# Software Update Notification

Filename: Software Update Notification for DTS v3.31.doc      Doct. Version No: 1  
Date: April 2004      Author: M.T.Connah

<b>Product</b>	<b>PartNo./Version</b>
Zetasizer Nano series	PSW0085/3.31
Firmware	PFW0044/1.10

This document is the software release note for Zetasizer Nano series software P/N PSW0085 on software suite PSS0012-06 in accordance with DCO4036  
This software corrects two reported issues.

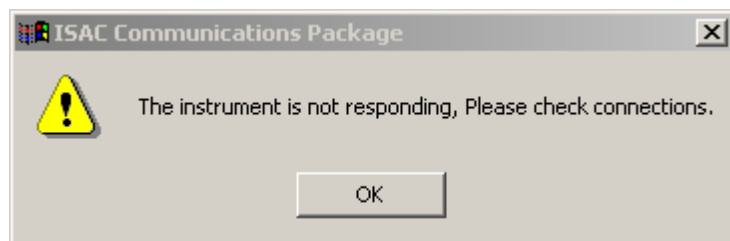
With version 3.30 is installed with the **Nano S option** selected the user will see the following,

Start a manual measurement

Select 'Autotitration' as the measurement type.

The sub-type option will now be shown and it will be incorrectly defaulted to 'Zeta potential'.

The other tabs in the manual measurement settings dialog will be those used to define a zeta potential measurement.

The user will also be unable to create size SOPs.

These errors are corrected in version 3.31
